**CITY OF MERIDIAN
FINDINGS OF FACT, CONCLUSIONS OF LAW
AND DECISION & ORDER**

Case No(s). H-2023-0045

STAFF REPORT

SUBJECT: Farmstone Crossing Subdivision AZ,
PP
[H-2023-0045](#)

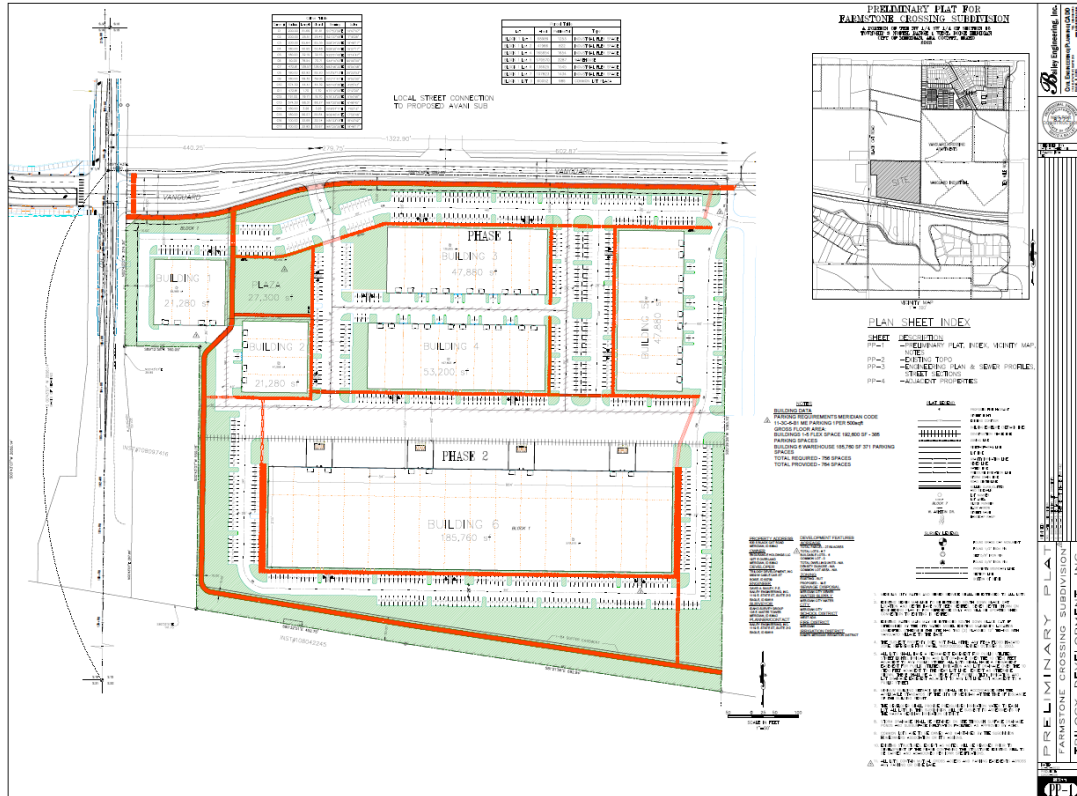
Vanguard Way should be constructed in accordance with Street Section C (major collector street) in the TMISAP, which requires (2) 11-foot travel lanes, 6-foot bike lanes, 8-foot parkways with streetlights at a pedestrian scale, and minimum 6-foot wide detached sidewalks (see pg. 3-20, 3-22, 3-23). The Applicant proposes a modification of the street section to include 10-foot wide detached sidewalks/pathways in lieu of on-street bike lanes, which is required by ACHD and as set forth in the Meridian Master Pathways Plan.

All streets should be constructed as complete streets as defined in the TMISAP (see pg. 3-19 & 3-20). Prior to submitting the final plat, the Applicant shall coordinate with the property owner to the north and east to construct Vanguard Way and deed the right-of-way to ACHD. The Applicant should ensure that the intersection of Vanguard Way and S. Black Road aligns with the entrance of the Black Cat Industrial projects on the west side of S. Black Cat Road.

The Applicant is proposing two curb cuts off of Vanguard Way, a planned collector street in the TMISAP. In accordance with UDC 11-3A-3 (Access to streets), multiple accesses off an arterial and/or collector roadway shall be restricted. **The Applicant has chosen to eliminate the curb cut aligned with the proposed subdivision to the north and has instead opted for the one closest to the intersection of Black Cat Road. Typically, Staff recommends that curb cuts align directly across roadways; however, Staff supports the offset change, given that the entrance effectively highlights the features of the proposed plaza, provided it adheres to ACHD's requirements. Additionally, the Applicant has proposed establishing a shared access on the east side of this site in collaboration with the property owner to the east, intended for future shared access.**

FIGURE 1

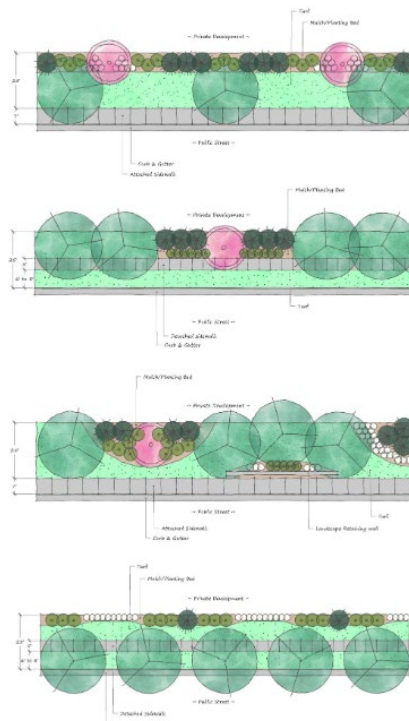
The Applicant should revise the landscape plan to reflect landscaping within the required buffers along Vanguard Way and Black Cat Road adjacent to the drainage swale in front of the 10-foot pathway in accordance with the standards listed in UDC [11-3B-7](#), which requires a variety of trees, shrubs, lawn or other vegetative groundcover (see figures below).

- a. Depict landscaping within required street buffers along Black Cat Road adjacent to the drainage swale in front of the 10-foot pathway and Vanguard Way in accord with the recently amended standards listed in UDC [11-3B-7C and 11-3B-8C](#); all required landscape buffers along streets shall be designed and planted with a variety of trees, shrubs, lawn, or other vegetative ground cover. Plant materials in conjunction with site design shall elicit design principles including rhythm, repetition, balance, and focal elements

D. Landscape Plan Rendering

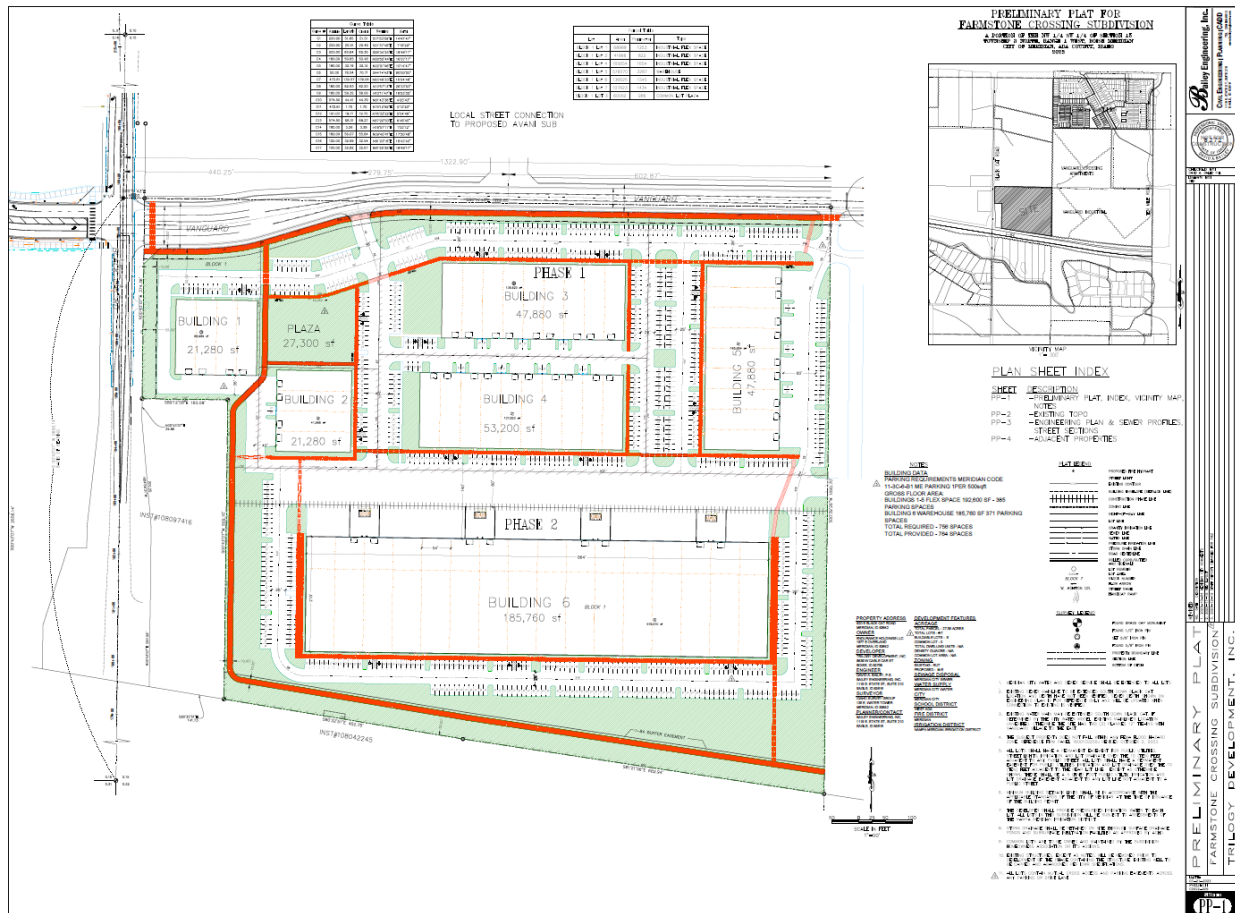
Mitigation is required for all existing trees 4" caliper or greater that are removed from the site in accord with the standards in UDC 11-3B-10C.5. Mitigation calculations are depicted on the landscape plan in accord with UDC standards (i.e. 149 trees at 2 caliper inches each for a total of 284 caliper inches). **The location of mitigation trees shall be depicted on a revised landscape plan submitted with the final plat application.**

- c. The location of mitigation trees shall be depicted on a revised landscape plan submitted with the final plat application.
- 2.4 A 14-foot wide public use easement for the multi-use pathways within this site shall be submitted to the Planning Division prior to submittal for City Engineer signature on the final plat(s).
